UNITED STATES PATENT AND TRADEMARK OFFICE

APPLICATION NO.	FILING DATE	FIRST NAMED INVENTOR	ATTORNEY DOCKET NO.	CONFIRMATION NO.
17/018,099	09/11/2020	Jason Wersland	76840-5090	2849

Office Action Summary	Application No. 17/018,099	Applicant(s) Wersland et al.	
	Examiner COLIN W STUART	Art Unit 3785	AIA (FITF) Status Yes

FIG. 11A

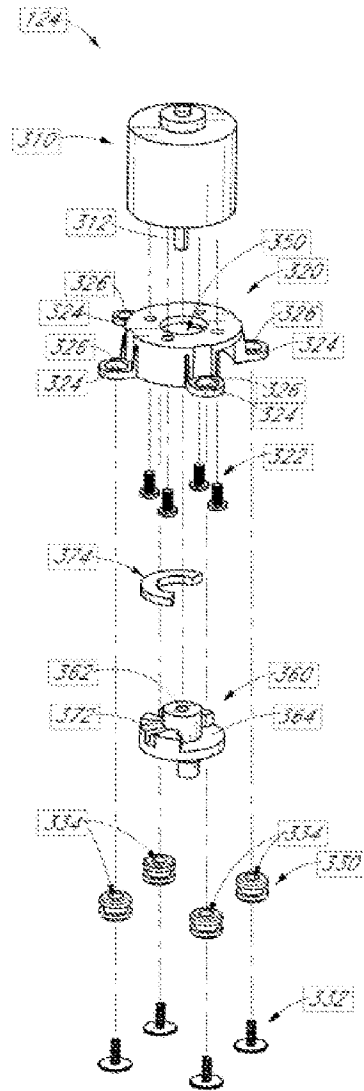
Regarding claim 2, the modified Pepe device teaches a motor (see Pepe para. 0026), but is silent as to the motor being a brushless motor with a rotatable motor shaft, wherein the percussive therapy device further comprises a motor mount positioned in the housing, wherein the motor mount includes a mounting wall having a shaft opening defined therein, wherein the motor is mounted to the mounting wall and the motor shaft extends through the shaft opening, wherein first and second mounting flanges extend from and extend perpendicular to the mounting wall, and wherein the first and second mounting flanges are secured to opposite sides of the housing. However, Marton teaches a similar device which includes a brushless motor with a rotatable motor shaft (see Marton Fig. 3, motor 310, see col. 9 ln. 60), wherein the percussive therapy device further comprises a motor mount positioned in the housing (see Fig. 3 and 11A-B, motor mount 320, col. 10 ln. 1-21), wherein the motor mount includes a mounting wall

having a shaft opening defined therein, wherein the motor is mounted to the mounting wall and the motor shaft extends through the shaft opening (see Fig. 11A-B, mounting wall being the upper wall of 320 which motor 310 directly attaches to, shaft opening 350 through which the motor shaft 312 extends), wherein first and second mounting flanges extend from and extend perpendicular to the mounting wall, and wherein the first and second mounting flanges are secured to opposite sides of the housing (see annotated Fig. 11B below). Thus it would have been obvious to one of ordinary skill in the art before the effective filing date of the claimed invention to modify the modified Pepe device's motor to explicitly be a brushless motor and to mount to the housing via the motor mount, as taught by Marton, in order to provide improved efficiency of the motor and thus the device and to provide required structural elements to secure the motor in the housing.
